Amendments to the Drawings:

REMARKS/ARGUMENTS

FIG. 1
Prior Art

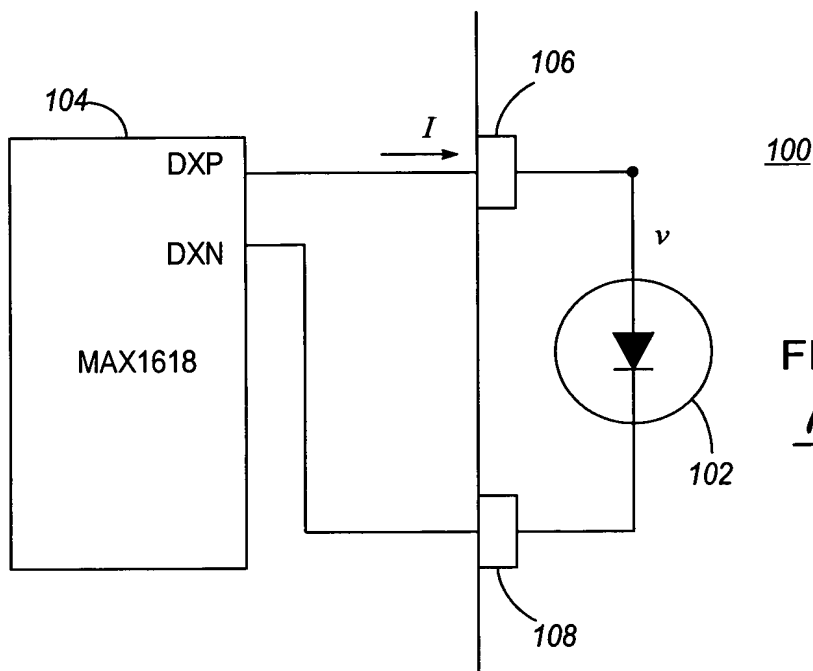
The attached sheet of drawings includes changes to FIG. 1. This sheet, which includes FIGS. 1 & 3, replaces the original sheet including FIGS. 1 & 3. In FIG. 1, the label --Prior Art-- has been added.

The Examiner objects to the drawings because FIG. 1 does not include a --Prior Art-- label. Applicants have amended FIG. 1 to include such a label, and this rejection is now believed to be moot.
